Subject: U.S. NRC Information Notice 89-66

"Field Notification Concerning the  
Qualified Life of ASCO Catalog NP-1 Valves"

"Revised Field Notification  
of the Discontinuation  
of NP8323 Valve Line"

## Revised Field Notification of the DISCONTINUATION OF NP8323 VALVE LINE

PIPING DIAGRAM  
 FOR DUAL NP 8320 VALVE

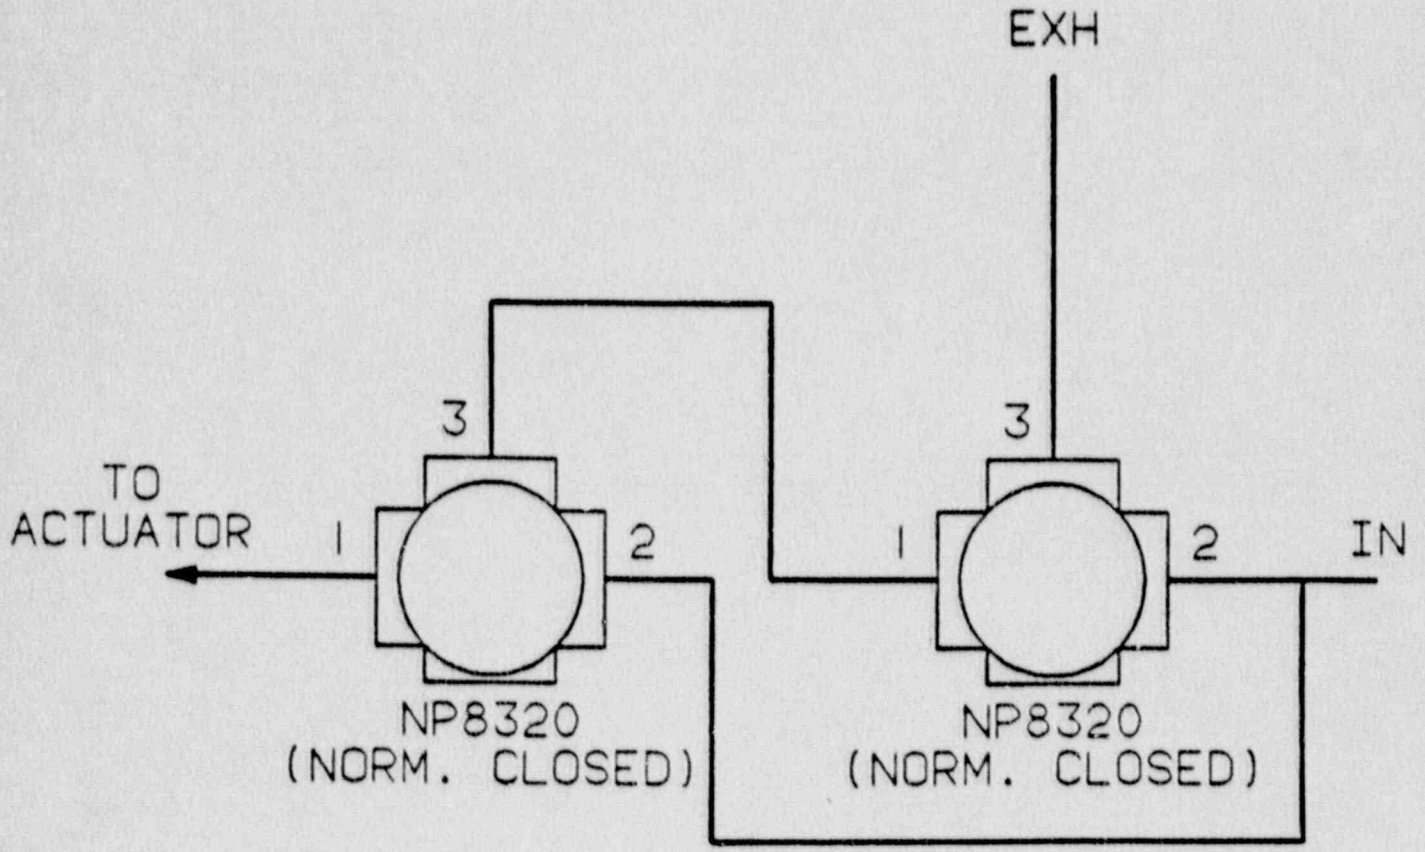
4. Fortunately, the NP8323 valves can be replaced with an alternate construction which is less vulnerable to foreign material contamination and offers distinct advantages. This alternative consists of a pair of NP8320 series valves with Viton elastomers. Although less tolerant of radiation, Viton provides superior performance in the MSIV piloting application. Two NP8320

series valves (normally closed construction) can be piped in a configuration which will duplicate the function of the presently used NP8323 pilots. Please refer to drawing FP238900 attached. Like the NP8323 series, the NP8320 series valves are fully qualified for safety-related applications with the following advantages:

- a. Superior pressure rating
  - b. Superior flow, and therefore, capability for faster shift times.
  - c. Lower operating temperature of critical components.
  - d. No core assemblies in the cylinder to exhaust path of the valves where ASCO has previously seen evidence of inhibited movement of the core assemblies due to foreign material contamination.
  - e. The NP8320 series valves are immediately available.
5. ASCO will be pleased to accept the return of any unused NP8323 valves and apply their value as credit against orders for other ASCO NP series valves.
